# 42 HONEYSUCKLE DRIVE COTTAGE CREEK PRECINCT NEWCASTLE

STATE SIGNIFICANT DEVELOPMENT (SSD-10378)  
DEVELOPMENT MODIFICATION 2

ARCHITECTURAL DESIGN STATEMENT

NOVEMBER 2021

# 1.1 DESIGN CHANGES FIRST FLOOR

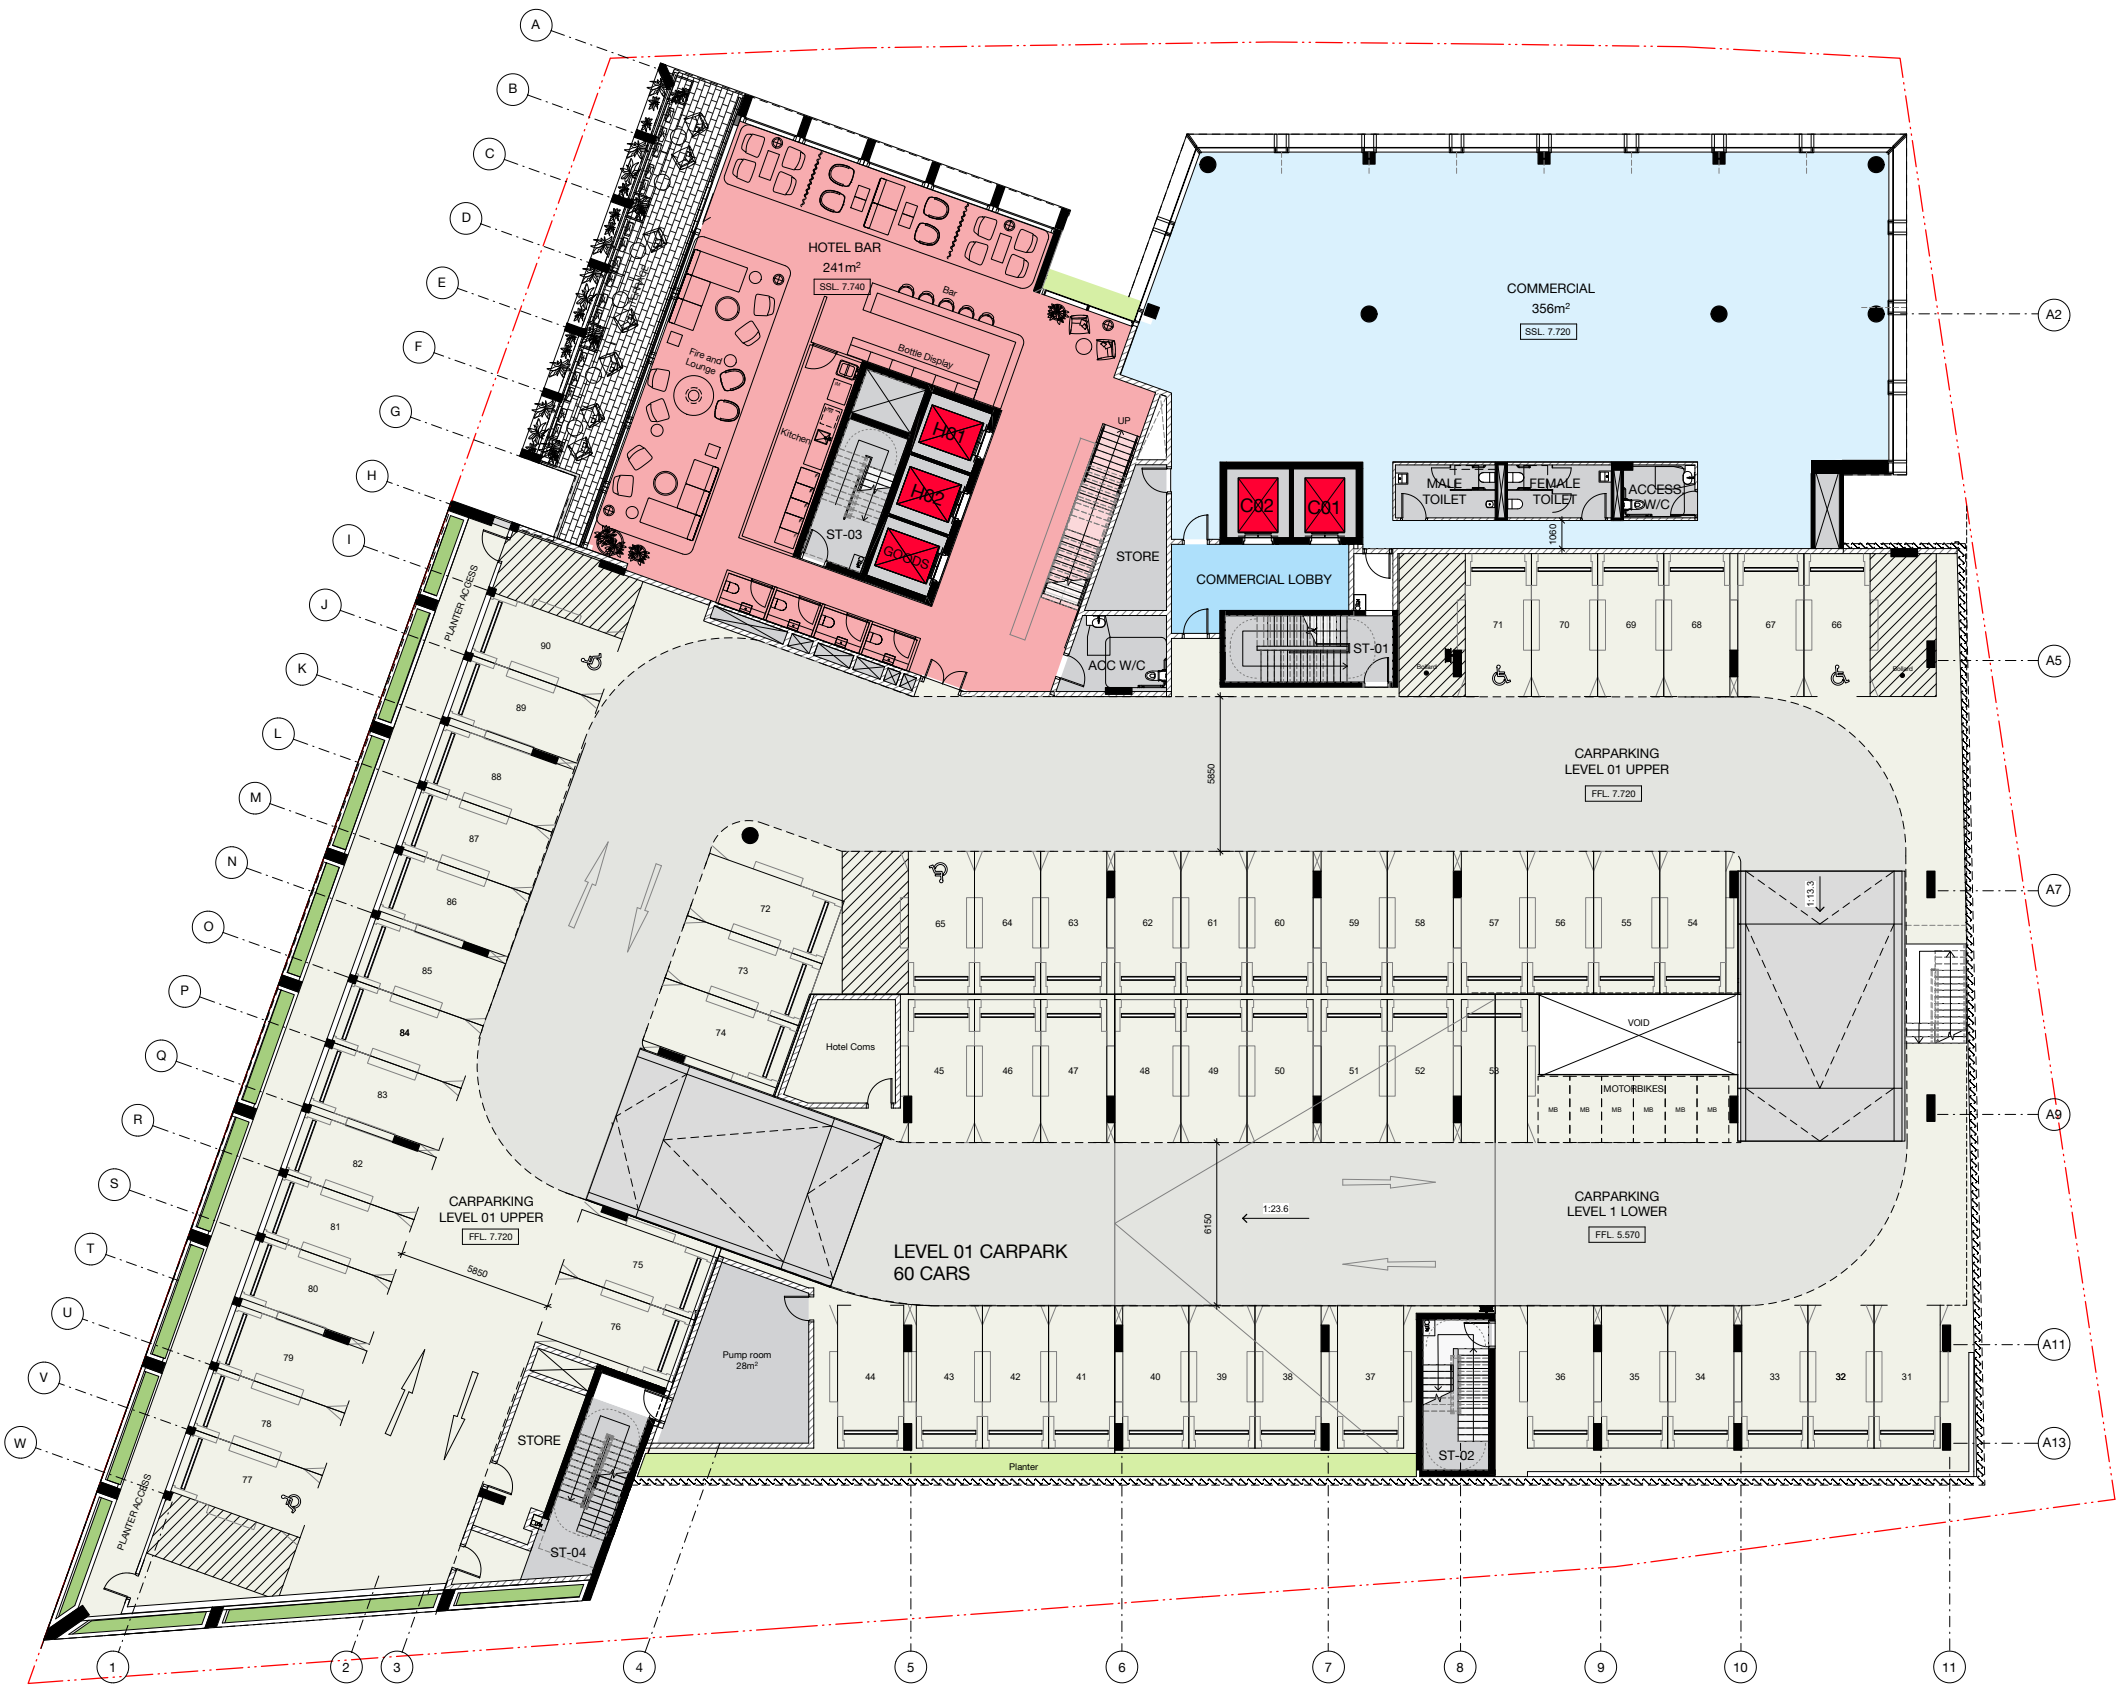
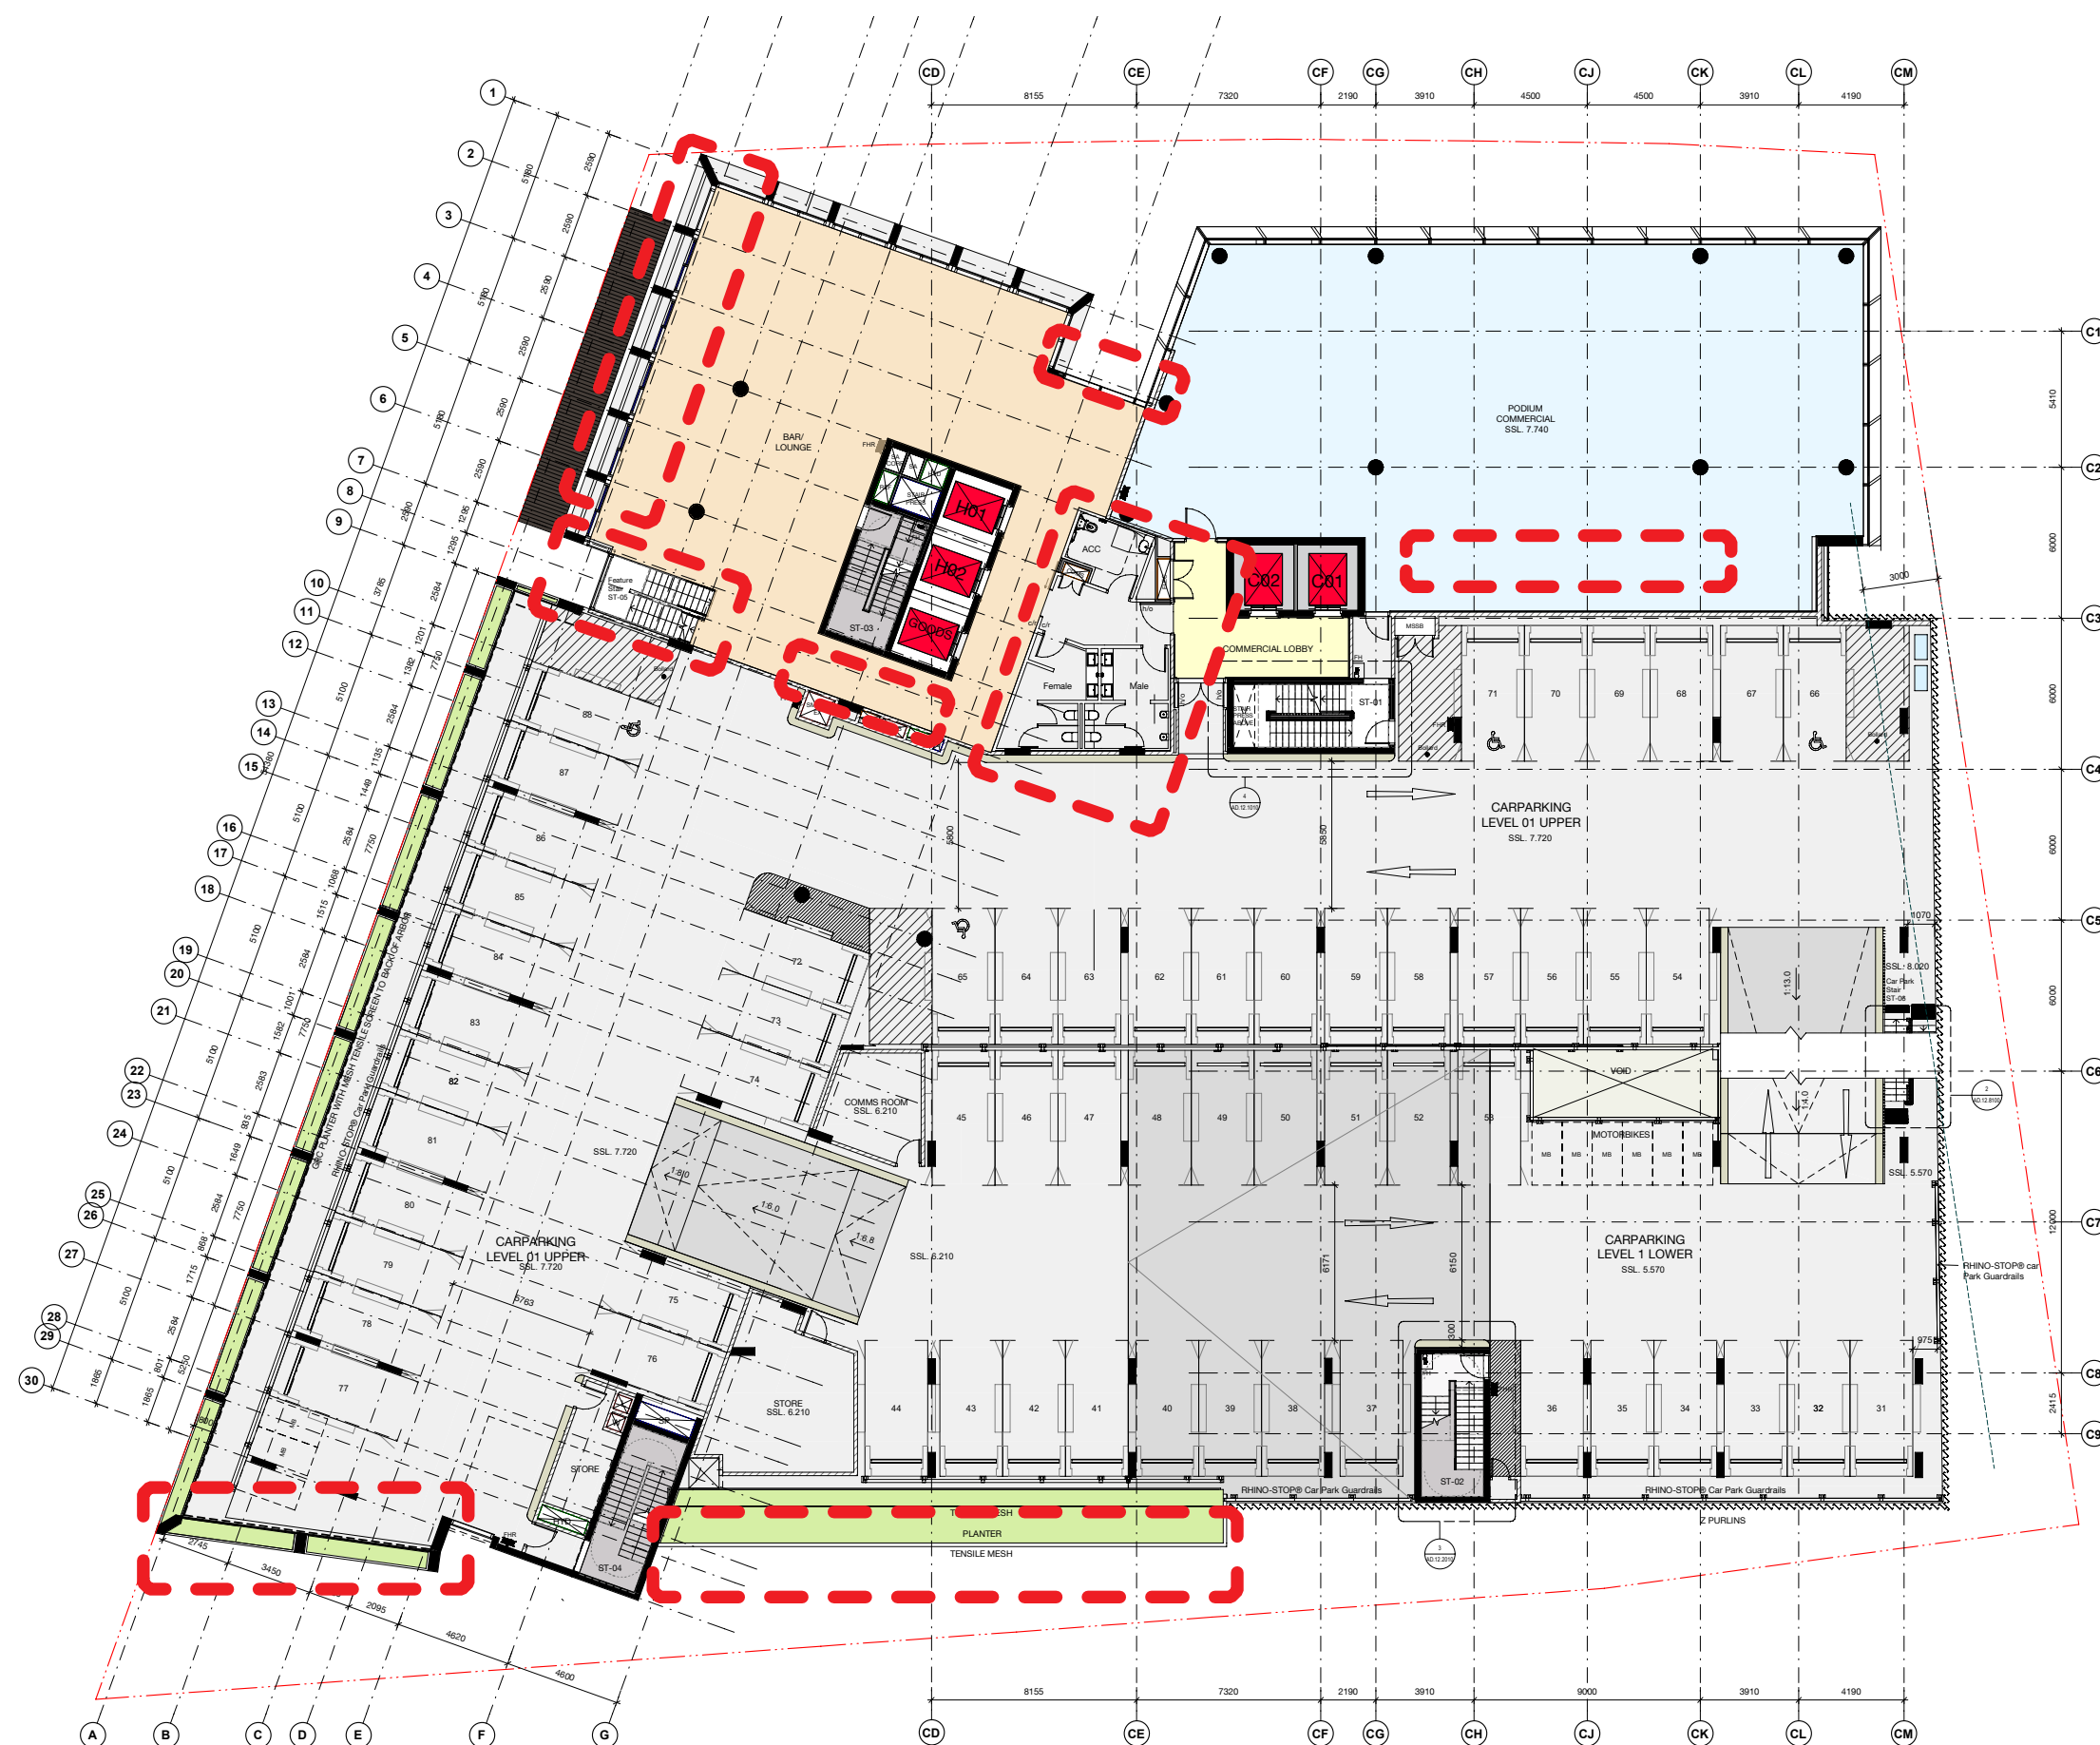
- 1 / South west end of the building at levels L00/L01/L02 set back from south boundary line.
- 2/ Amenities to commercial floor area shifted and combined with the hotel facilities.
- 3 / Feature stair relocated to the western side of the communal space. Stair links from ground floor to level L02.
- 4 / External western terrace off the hotel communal space omitted.
- 5 / Planter between building forms along the Northern elevation at levels L01 and L02 omitted.
- 6 / Loss of 2 parking spaces due to a reduction in the western elevation length
